# Colour & Co. Ltd.

Tepirbari, Sreepur, Gazipur

3 March 2024

## 2. Observations

Cylinder test report (Column and slab)

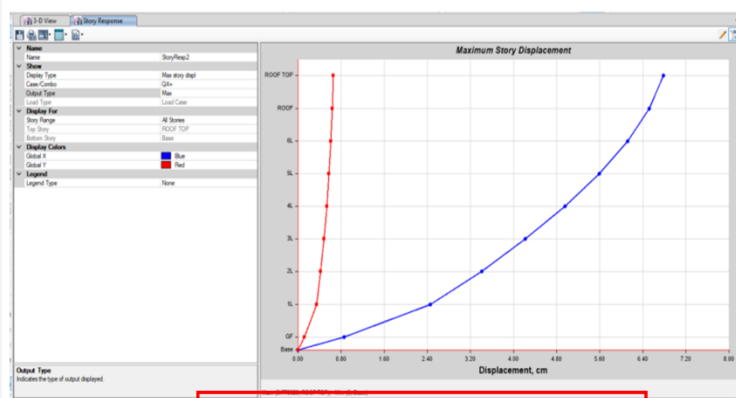
**Description:** In the design report, concrete strength of columns and beams were considered 31 MPa and 27.6 MPa respectively. However, to consider this concrete strength, the number of cylinders taken are not adequate as per the frequency test criteria of BNBC (Section 5.12) since there are only 9 sets of cylinder test reports (2 from columns, 7 from slabs). The building engineer is required to take adequate core samples to verify the in-situ strength of concrete.

### Beams designed as sway special

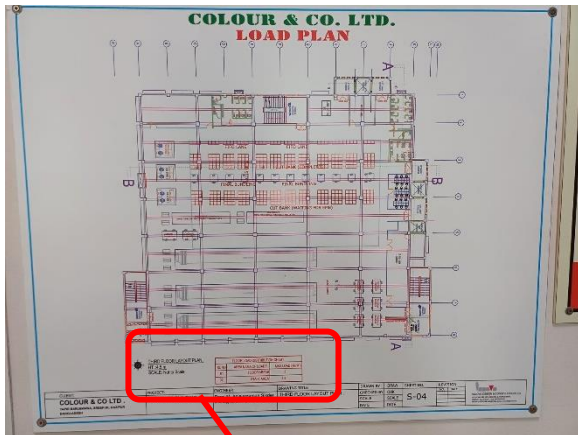
In the design report, lateral sway is checked for earthquake load cases although the deflection limit is provided for wind load case. The building engineer is required to check the lateral sway for wind load also. As per design report, maximum required reinforcement of 600X600 column is 4.63% at ground floor, however, maximum provided reinforcement of any 600X600 column is 2.11%. The grade and floor beams have been designed as sway special although value of R has been considered for Intermediate Moment Resisting Frame.

The building engineer is required to revise the Detailed Engineering Assessment (DEA) report and submit it to the RSC for further review.

load plan of 3<sup>rd</sup> floor

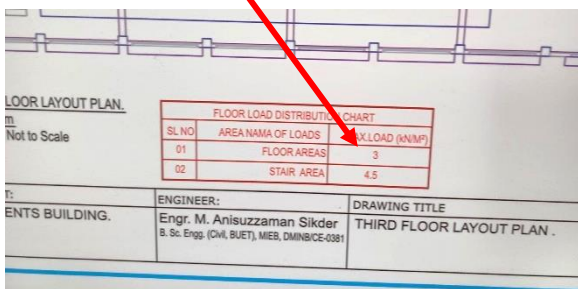
**Description:** As per BNBC, 6 kPa is required to consider floor loading for the light storage facilities. During the inspection, the load plan was found posted considering 3 kPa at the storage area. Height marking was not provided.

The Building Engineer is required to update the storage live load limit as per BNBC requirements and revise the structural analysis & DEA report accordingly. Post the updated load plan and provide storage height markings.

#### Missing details of steel stairs and soil thickness at the roof

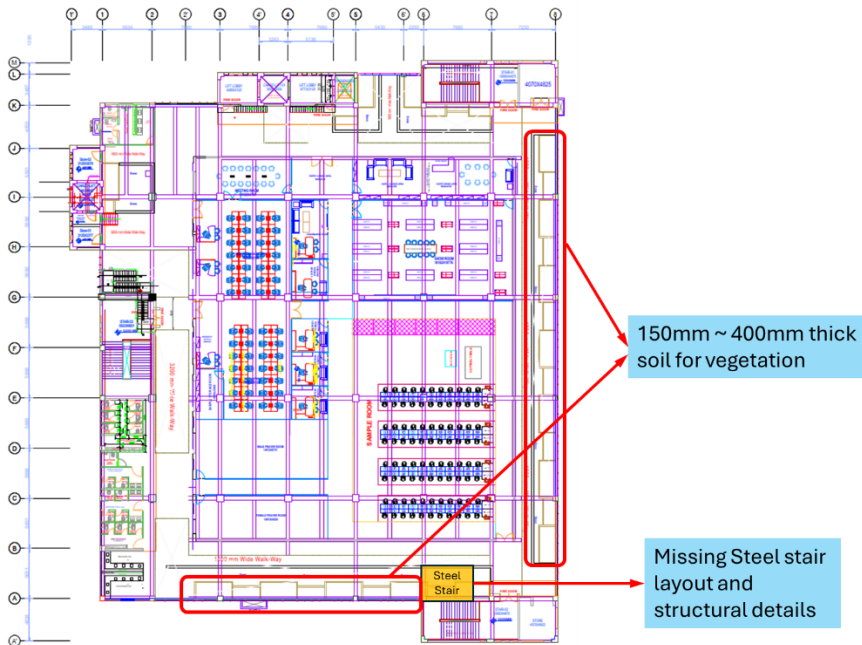
- Mismatch was found in the marked column sizes (C1, C2 and C3 column sizes were found 900X900 at 1<sup>st</sup> floor, C7 and C8 column sizes were found 700X700 at 1<sup>st</sup> floor).
- Layout and structural details of steel stairs at the roof were found missing.
- There is Gardening on the roof. However, in architectural drawings, there is no mention of soil thickness.

The building engineer is required to survey the full structure and update the as-built drawings and DEA report accordingly.

#### Mismatch in column size

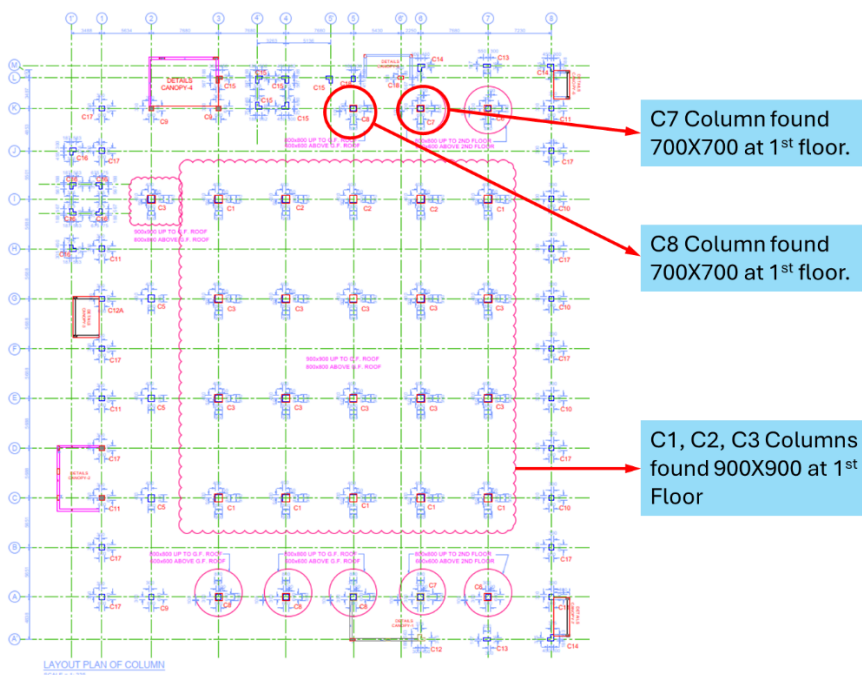
C7, C8 Column at 1<sup>st</sup> floor.

C1, C2, C3 Column at 1<sup>st</sup> floor.

**Observation-5:** Rebar on the roof is not properly sealed. (Building-1)

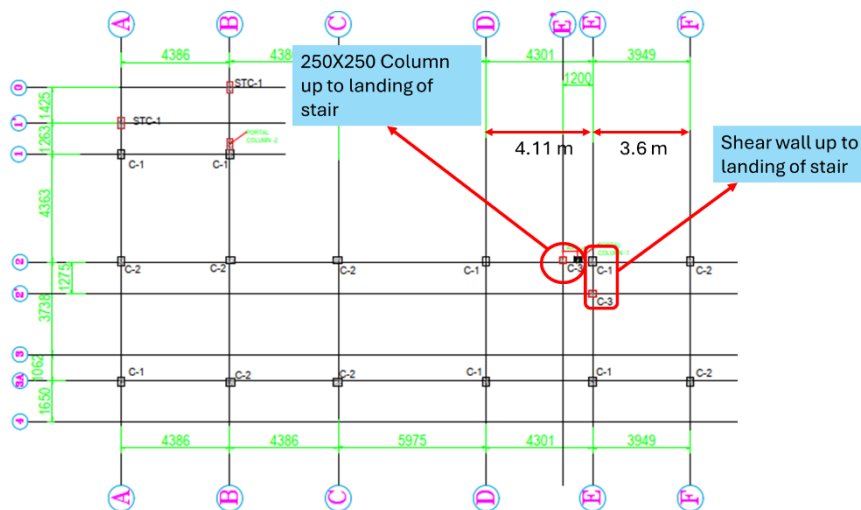
**Description:** During inspection, reinforcements of columns at the roof were found improperly sealed and prone to corrosion. The building engineer is required to cover all the exposed rebars in suitable method.

Missing schedule of C3 Column

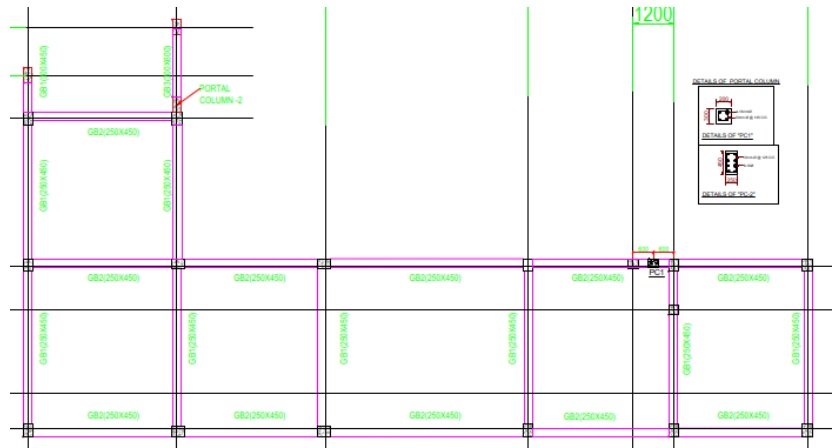
- Mismatch was found in the marked grid distances.
- A shear wall was found supporting the landing of the stairs. In structural drawing, two columns are shown in place of the shear wall.
- In grid 2-E', C3 column is shown. However, a 250X250 RC column was found in place of the C3 column. Another 250X250 RC column was found supporting the landing of the stairs in place of the brick pier shown in the drawing. Details of C3 column are missing in the column schedule.
- Mismatches were found between the grade beam and floor beam layouts and sections.

The building engineer is required to survey the whole structure and update the as-built drawings as per site conditions.

Mismatch in grade beam and floor beam sizes between beam layout and section

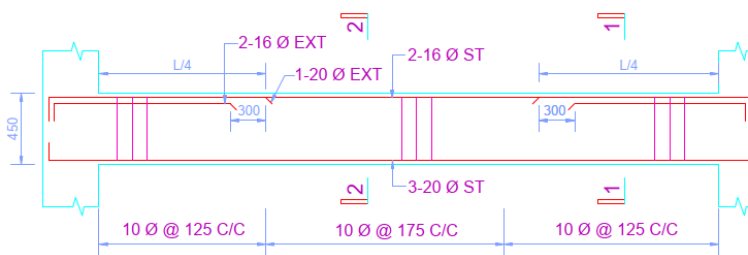
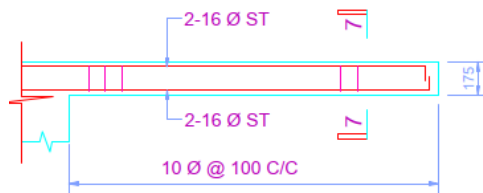
Grade Beam size shown 250X450 in layout

Figure - 3.0: Max Story displacement for QX+ (3.6mm) of Structure.

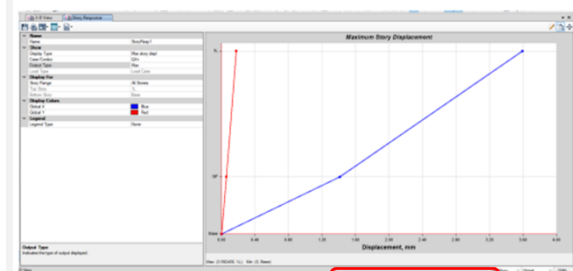
Mismatch in the load case in the lateral sway check

In the design report, lateral sway is checked for earthquake load cases although the deflection limit is provided for wind load cases. The building engineer is required to check the lateral sway for wind load also. Floor beam sizes were found 250X450 on-site. As per the design report, the value of R has been considered for the Intermediate Moment Resisting Frame (IMRF). However, the spacing of transverse reinforcement of the beams doesn't comply with the requirement of IMRF.

The building engineer is required to revise the Engineering Assessment (EA) report and submit it to the RSC for review.

Floor Beam Section

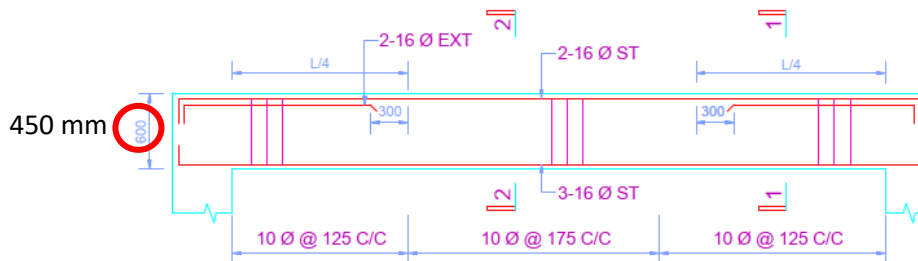
**Description:** During the inspection, mismatches were found in the as-built drawings of the floor beam and grade beam. The floor beam size was found 250X450 on-site whereas the section of floor beams in the as-built drawing shows 300X600. The building engineer is required to survey the full structure and update the as-built drawings and EA report accordingly.

**Observation-10:** Design documents need to be reviewed for lateral forces. (Shed-1)

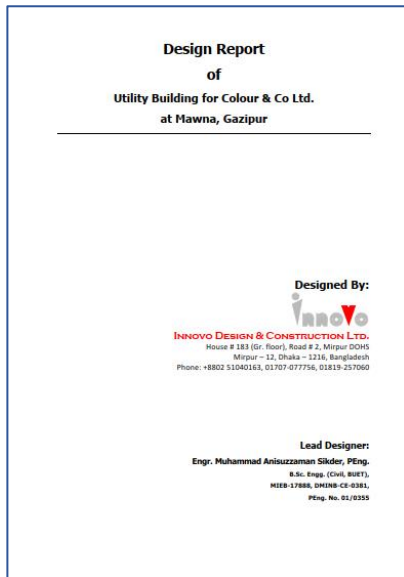
**Description:** During the inspection, a structural design report and as-built drawings were available on site which need to be reviewed by RSC in depth for lateral forces. Serviceability checks have not been provided in the design report and connection adequacy checks are also missing. The building engineer is required to revise the Engineering Assessment (EA) report, submit it to the RSC for review and implement remedial works if required.

**Observation-11:** Design documents need to be reviewed for lateral forces. (Shed-2)

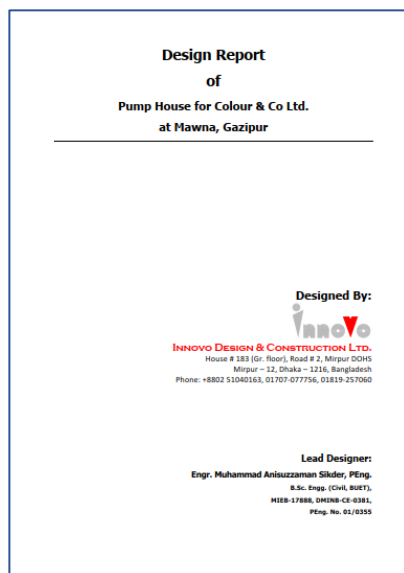
**Description:** During the inspection, a structural design report and as-built drawings were available on site which need to be reviewed by RSC in depth for lateral forces. Serviceability checks have not been provided in the design report and connection adequacy checks are also missing. The building engineer is required to revise the Engineering Assessment (EA) report, submit it to the RSC for review and implement remedial works if required.
